Flores 24" Rehab Project- DR No 128
Solicitation Number: CO-00107-SM
Job No.: 14-4657

ADDENDUM 3
February 6, 2017

FLORES 24-INCH REHAB PROJECT, DR 128

SUMMARY OF QUANTITIES

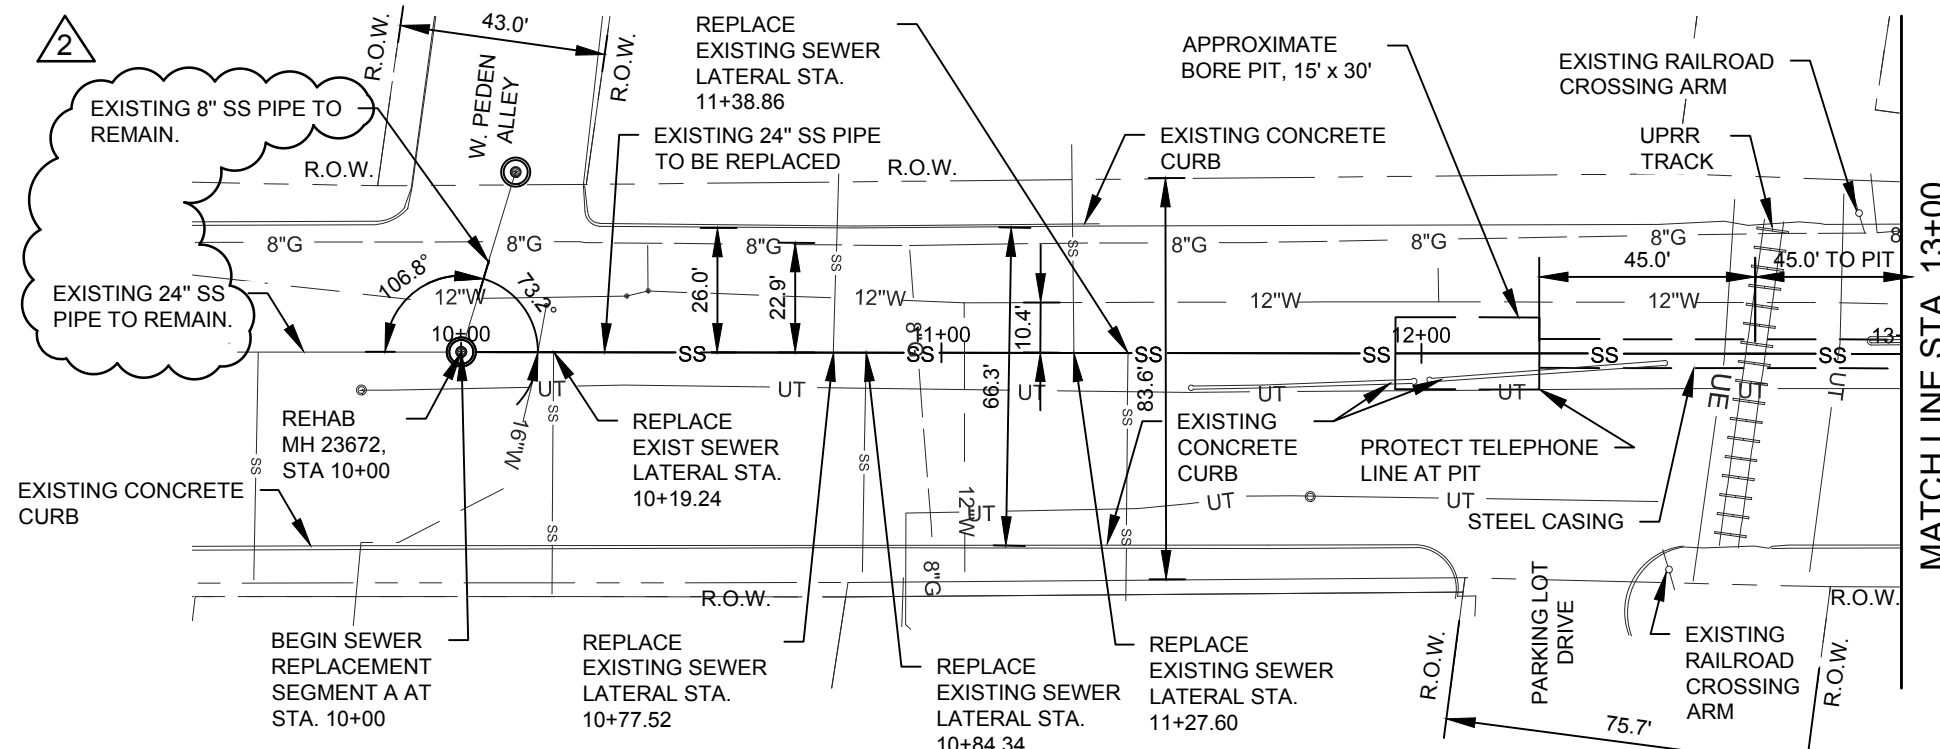
Sheet 2: Summary of Quantities table was modified to correct Item 901.0 to 910.0

Page BP-2, Bid Proposal, Line No. 39, Change Item Number 901.0 to 910.0

FLORES 24-INCH REHAB PROJECT, DR 128 SEGMENT A PLAN AND PROFILE STA. 10+00 TO 13+00

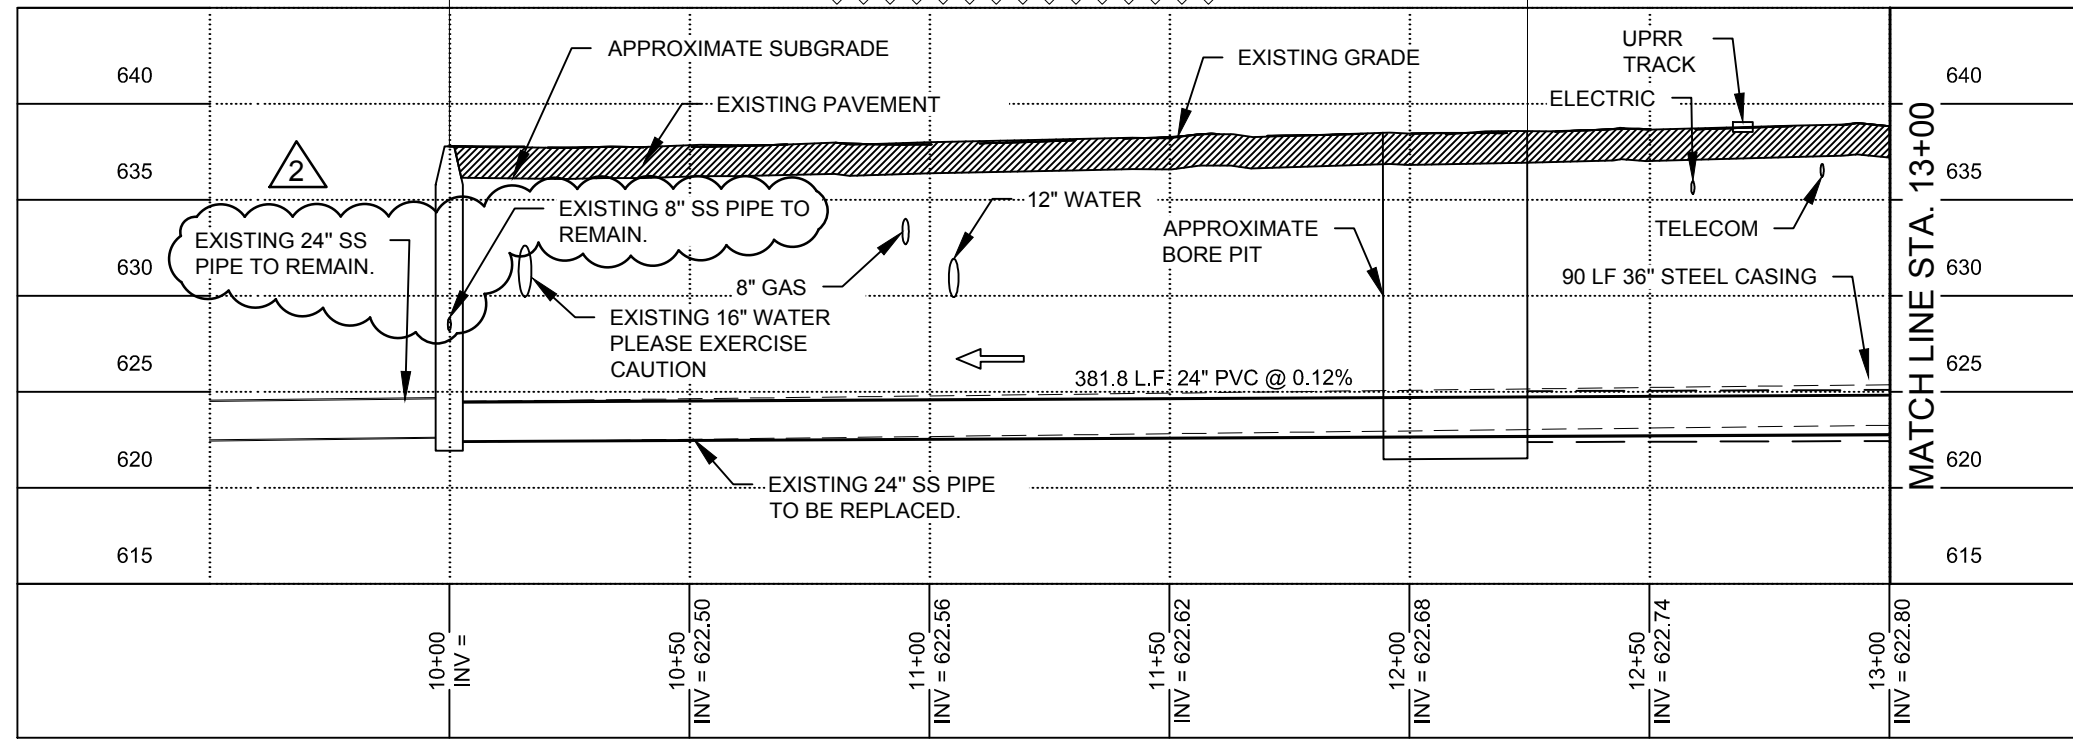
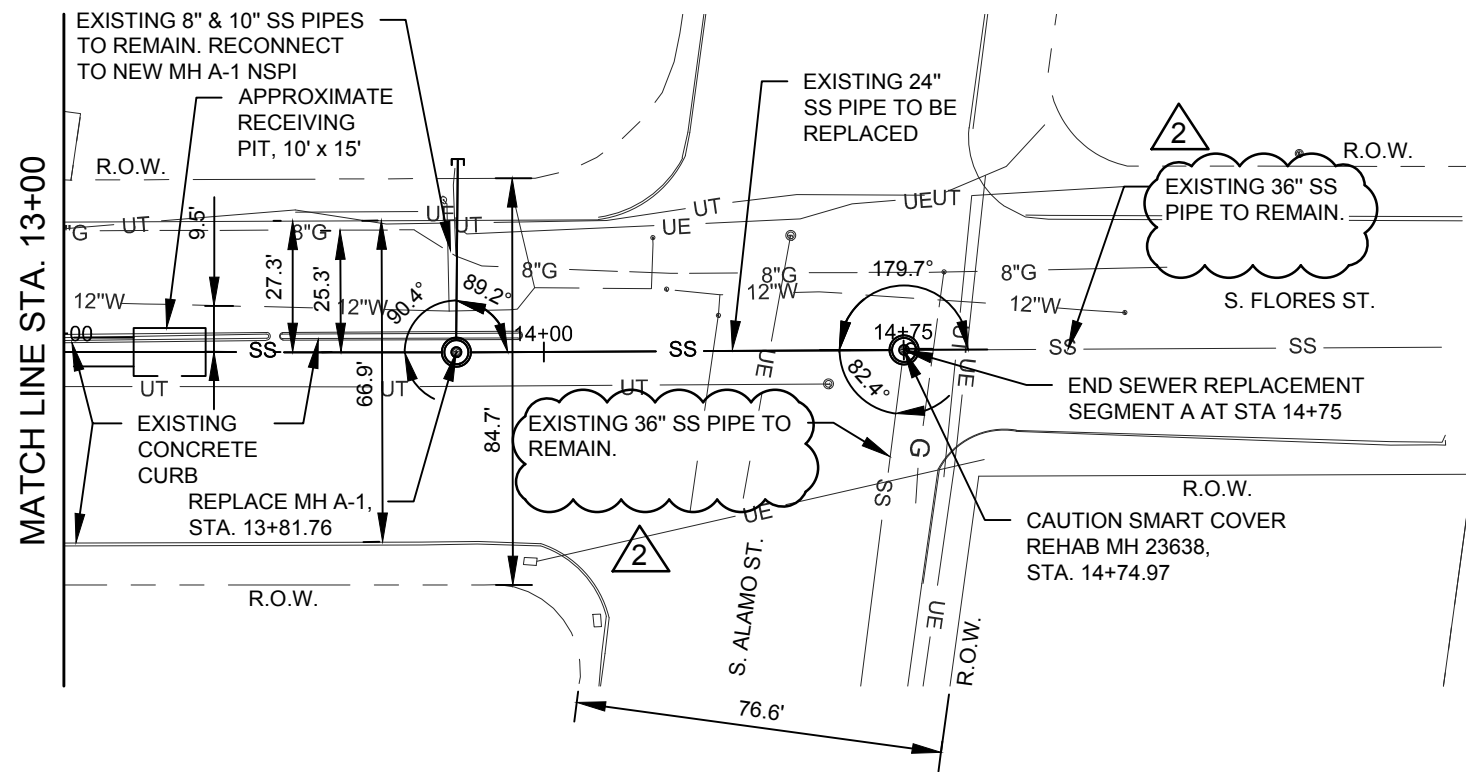
3. **Q: What is size and who is owner of underground telephone that is very close to bore pit on sheet 7.**

Sheet 7-12: Callouts referencing reconnecting existing pipes to new manholes has been corrected where manholes are not being replaced.

R: All underground are believed to be owned by AT&T; with the exception of a Verizon owned cable near the railroad tracks at 16+50. It is the responsibility of the Contractor to verify all existing utilities and ownership thereof as part of their scope.

FLORES 24-INCH REHAB PROJECT, DR 128 SEGMENT B PLAN AND PROFILE STA. 13+00 TO 16+00

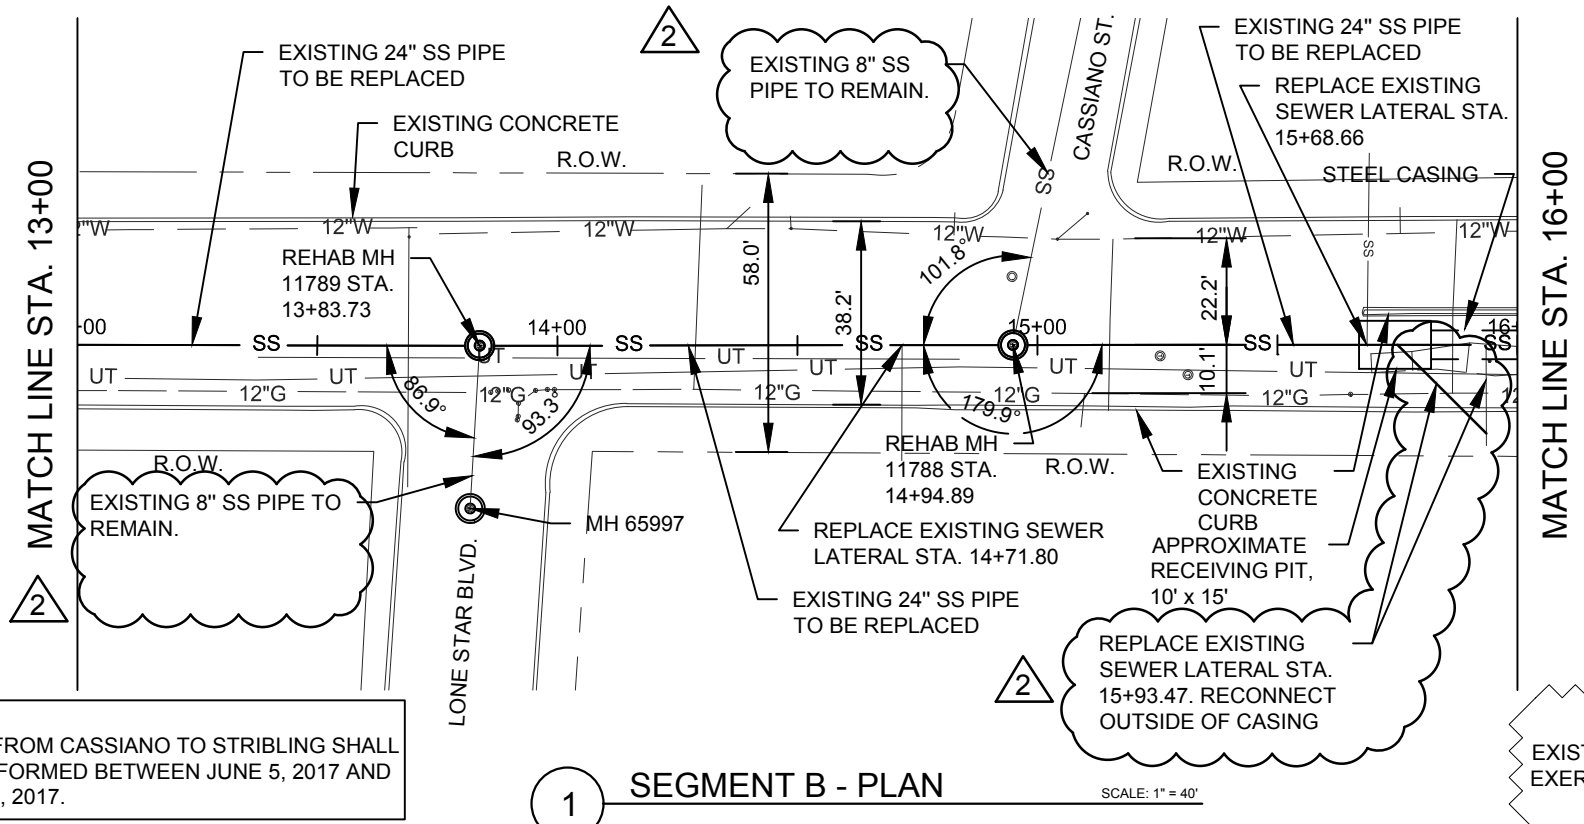
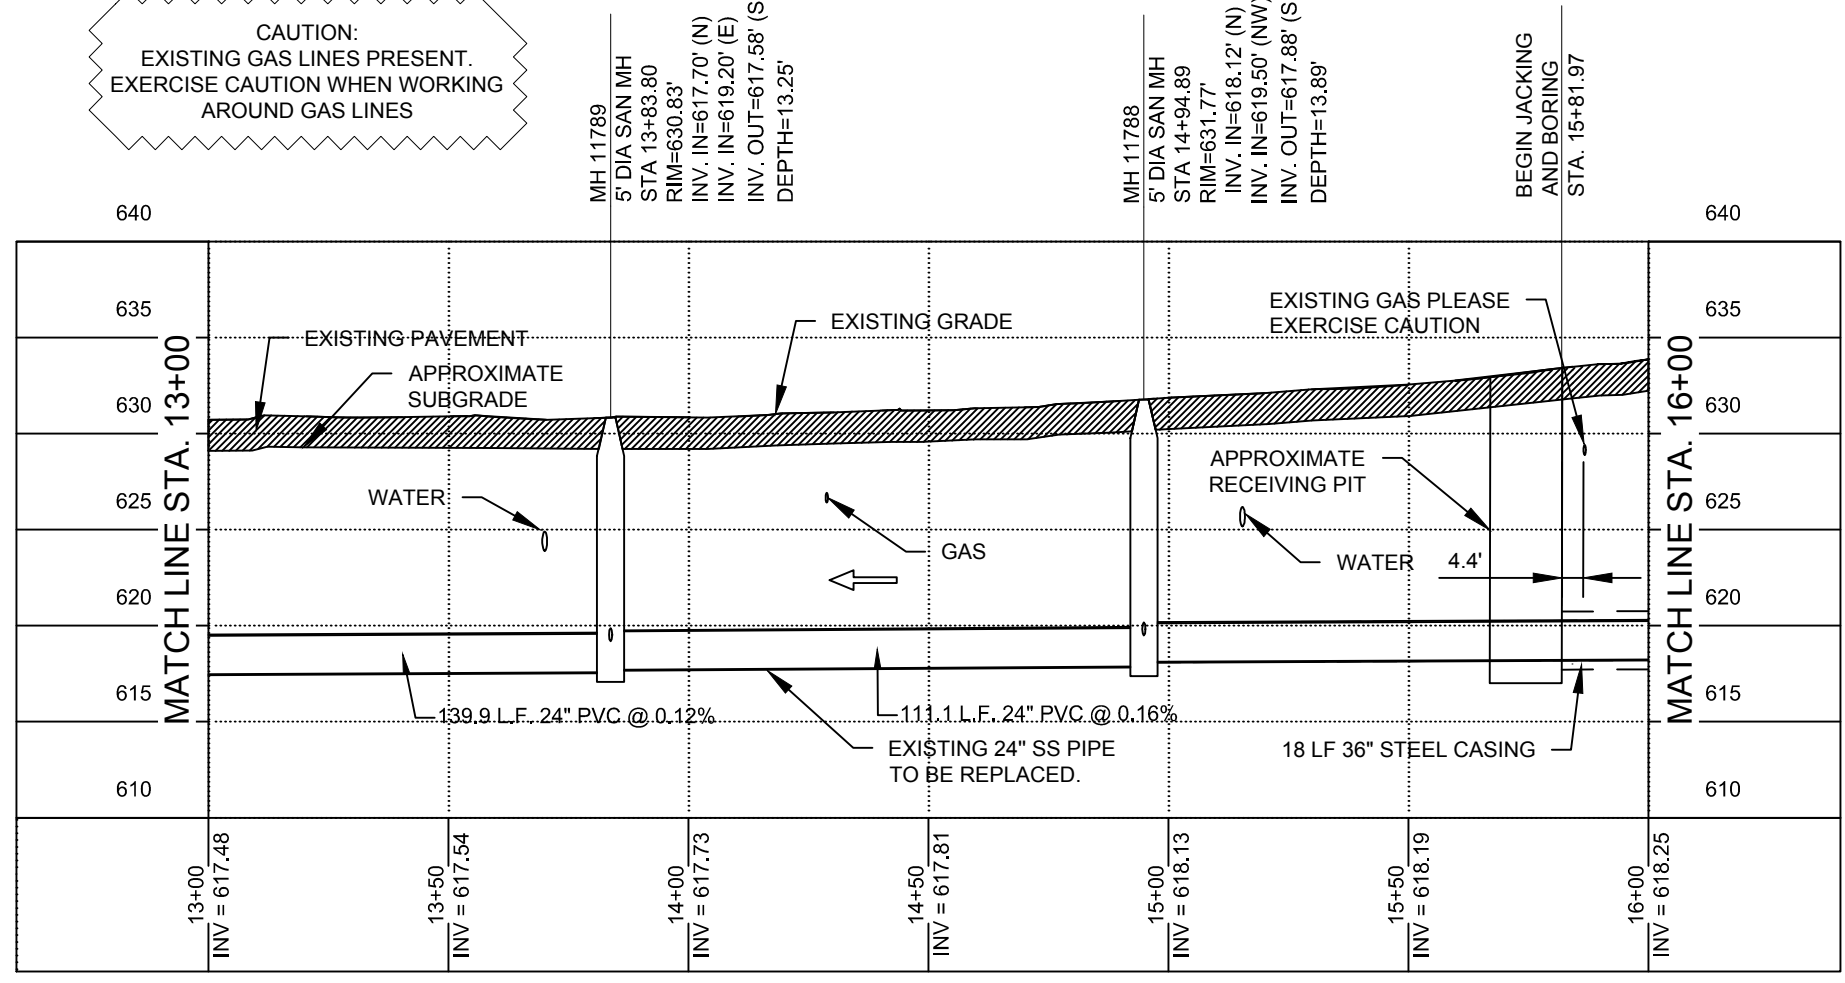
- 5. Q: There is a lateral on sheet sht 10 that appears to be in the proposed casing. Please provide additional information.**

Sheet 10: Revision to show new lateral location at 15+93.47

R: Lateral shown on Sheet 10 approximately at station 15+93.47 currently conflicts with proposed casing. New lateral installation will need to be rerouted to connect to main outside of casing, at approximately station 15+74 (See revised sheet).

TRAFFIC CONTROL PLAN ROAD CLOSURE LAYOUT ALTERNATIVE

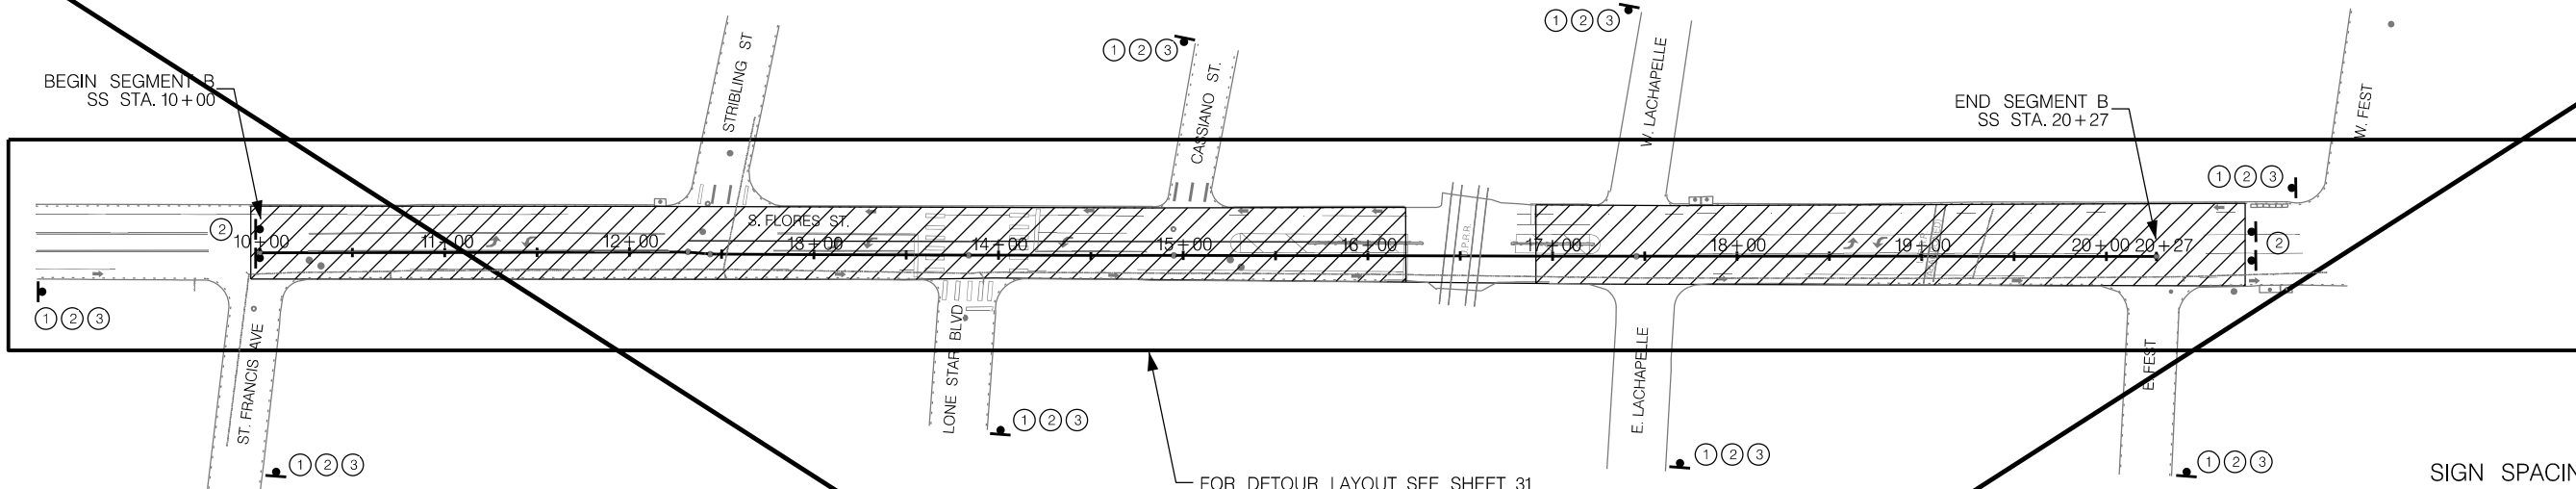
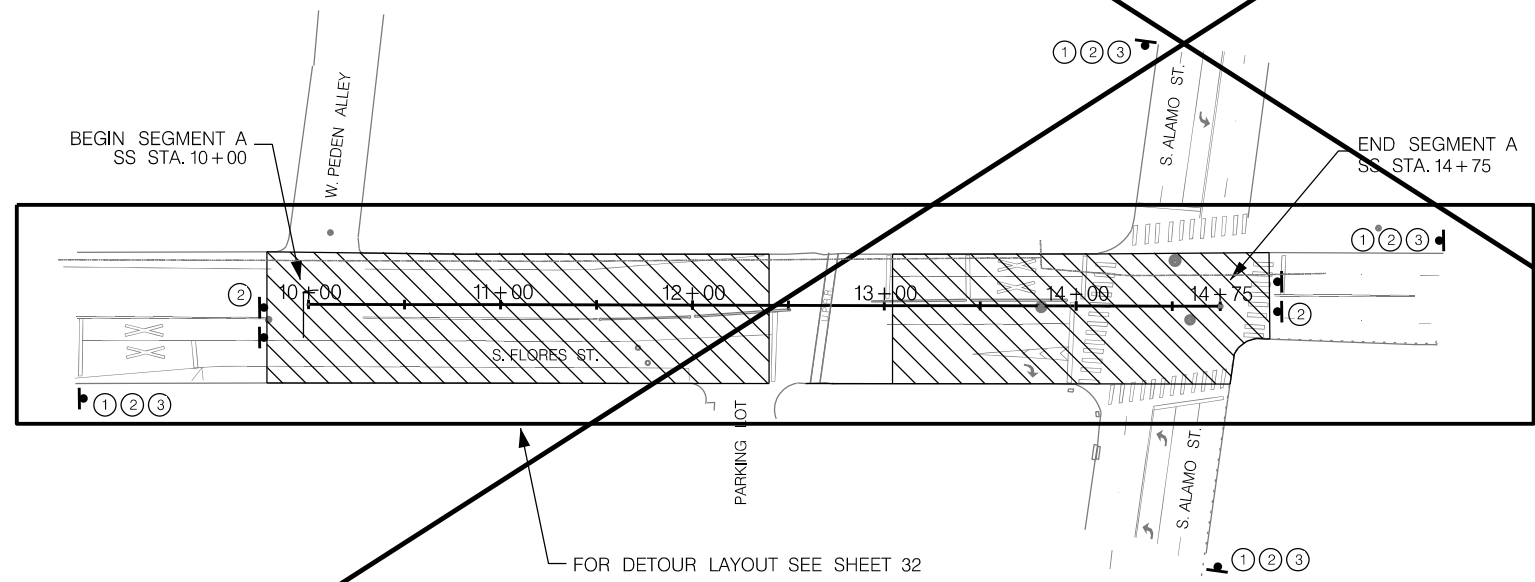
- 8. Q: How is the alternate TCP paid for? How will the use of this option be determined?**

Sheet 30-32: Alternative TCP has been removed

R: Alternate TCP for full street closure is being deleted from the project (See Changes to the Drawings below).
